1997 SEMINAR INFORMATION

"THE RIGHT DIRECTION FOR '97"

AUTOMATIC TRANSMISSION SERVICE GROUP
9200 S. DADELAND BLVD.
SUITE 720
MIAMI, FL 33156
(305) 670-4161

Figure 2

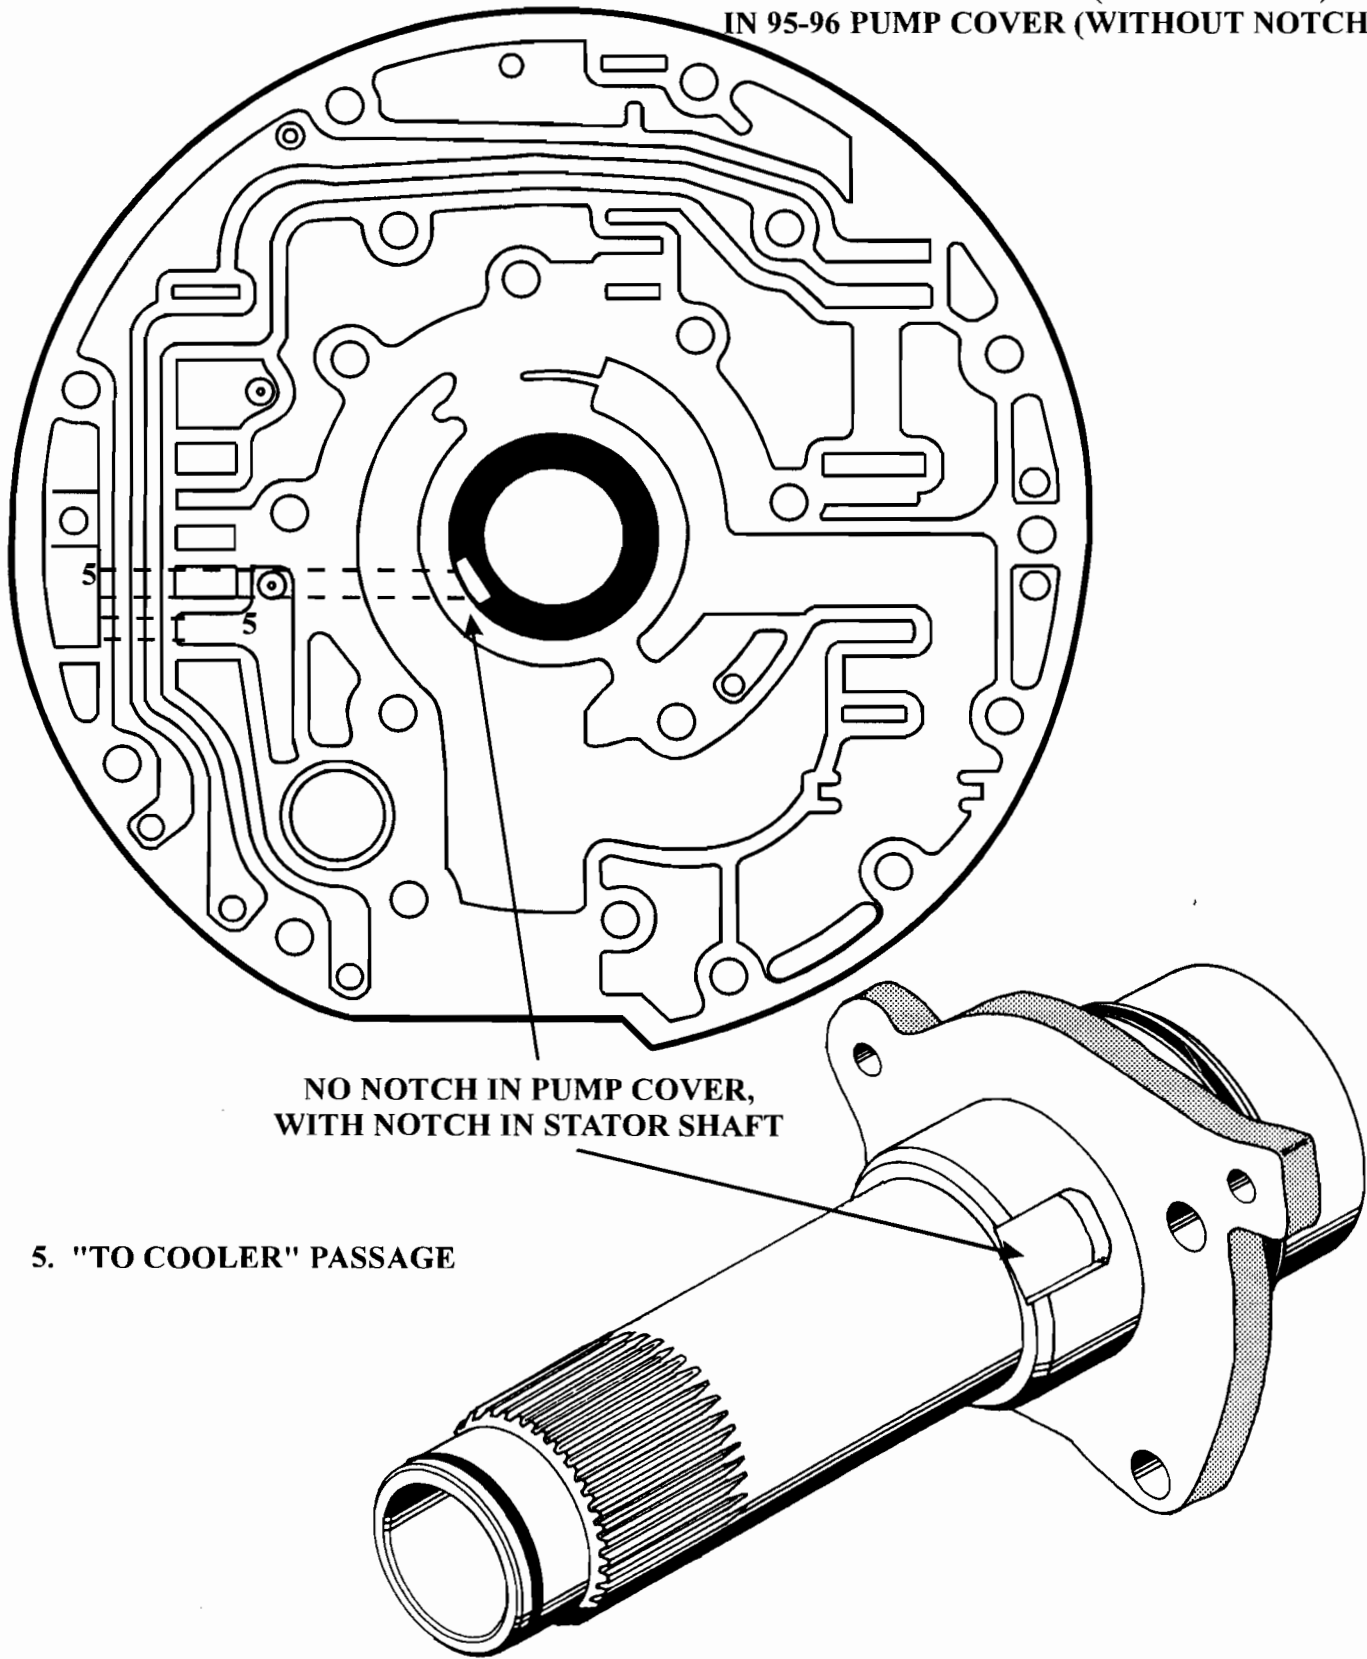
95-96 Model pump cover *without notch*, **MUST** be used with the stator shaft *with notch*. Refer to Figure 2.

CORRECTION: Install the proper stator shaft into the proper pump cover. The differences are as follows:

Figure 3

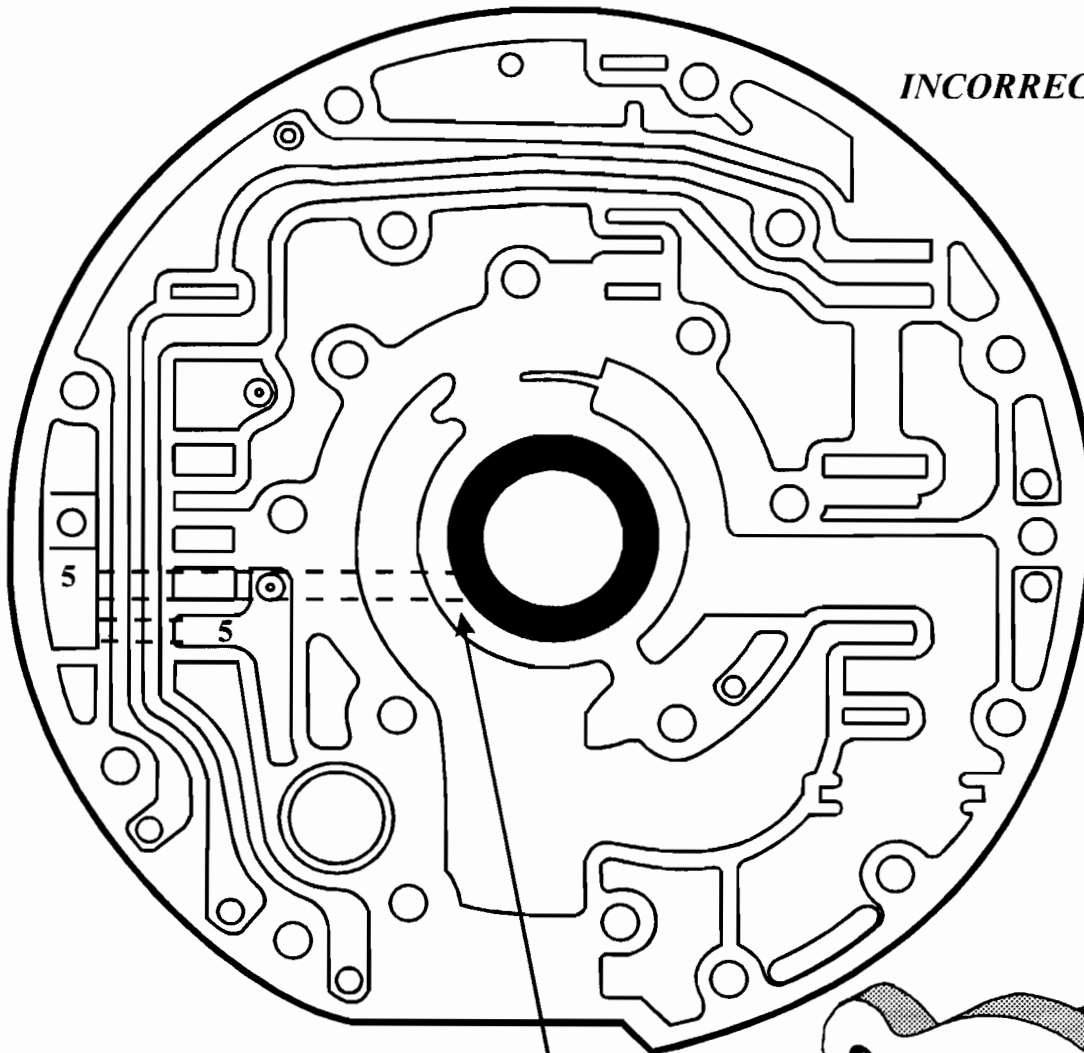
If you install a 89-94 stator shaft *without notch*, into a 95-96 pump cover *without notch* -- You will create a *totally blocked "To Cooler" passage* in the pump cover. Refer to Figure 3.

89-94 PUMP STATOR (WITHOUT NOTCH), IN 95-96 PUMP COVER (WITHOUT NOTCH)
RESULTING IN A *TOTALLY BLOCKED* "TO COOLER" PASSAGE.

1989-1995 MODEL REVERSE CLUTCH
PISTON AND SPRING RETAINER

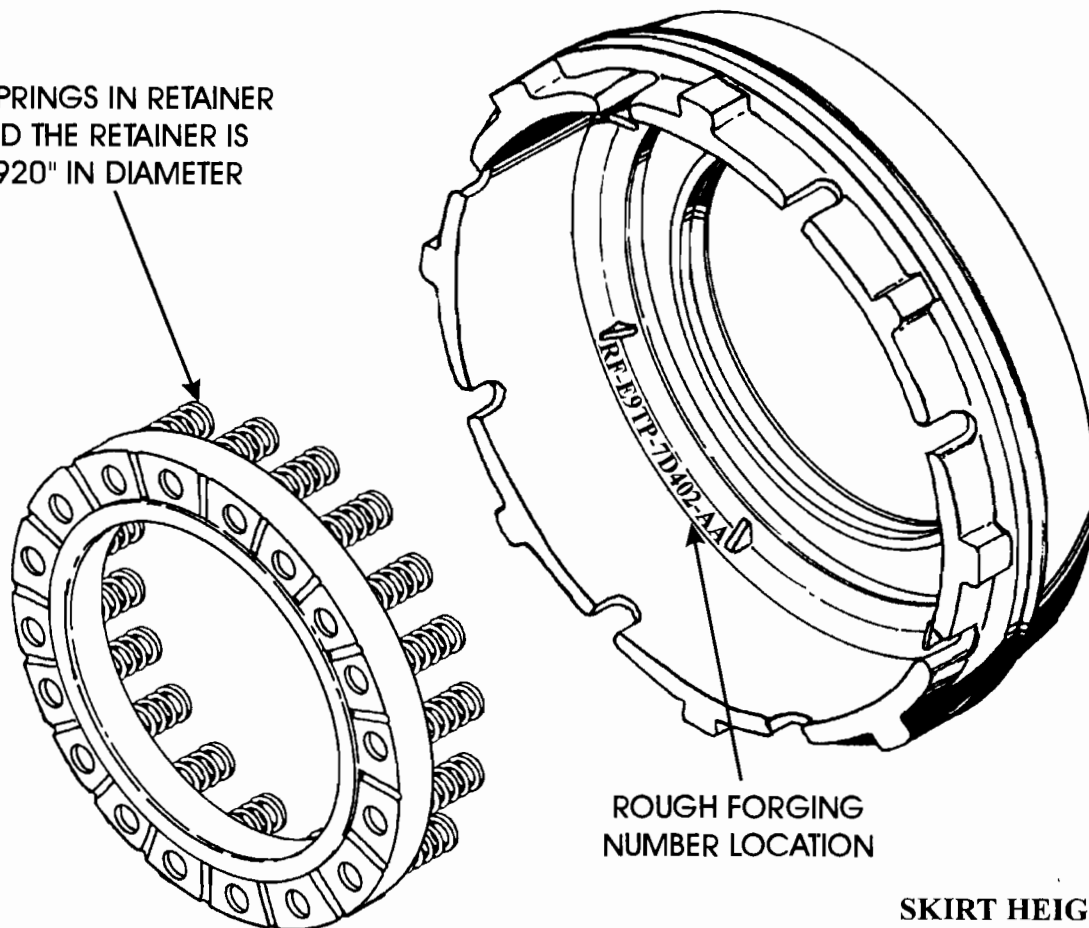
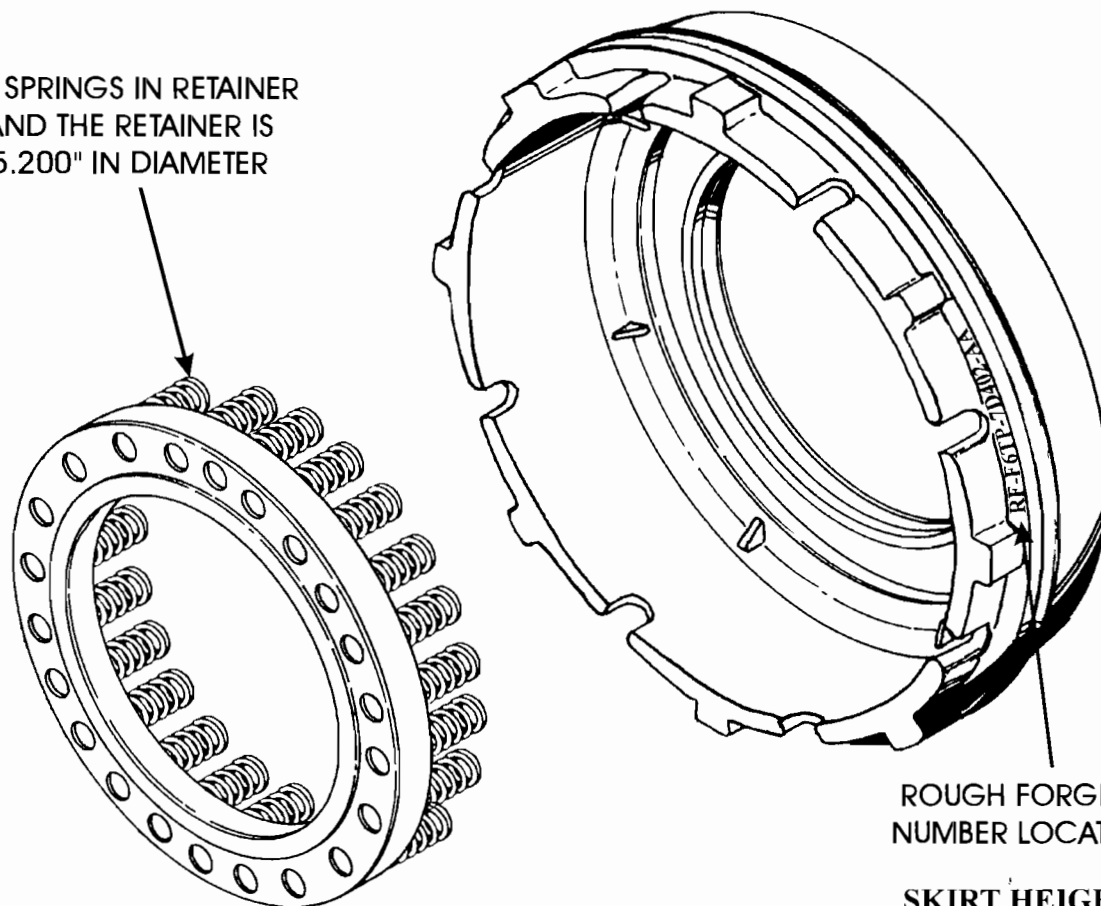
- (1) **REVERSE CLUTCH PISTON SEALS** - Change from the previous "Square" cut seals to the new design "Lip" seals, for increased sealing ability. Refer to Figures 1, 2 and 3.

- (2) **REVERSE PISTON** - Seal grooves in the piston are machined differently to accommodate the new design lip seals. The reverse piston skirt is also .140" shorter than the previous piston, to accommodate the added cushion (Wave) plate in the reverse clutch pack. This will obviously also affect the overall height of the piston. Refer to Figures 1, 2 and 3.
The pistons can be identified by the "Rough Forging" number, as shown in Figures 1 and 2.
Rough Forging Number RF-E9TP-7D402-AA = 89-95 Model (Square Cut Seals)
Rough Forging Number RF-F6TP-7D402-AA = 1996 Model (Lip Seals)

Reverse Clutch Piston (New Design)	F6TZ-7D402-A
Reverse Piston Outer Lip Seal (Package of 3)	F6TZ-7D403-A
Reverse Piston Inner Lip Seal (Package of 3)	F6TZ-7D404-A
Reverse Piston Return Spring Assembly (New Design)	F6TZ-7D406-A
Reverse Clutch Cushion Spring	F6TZ-7D085-A
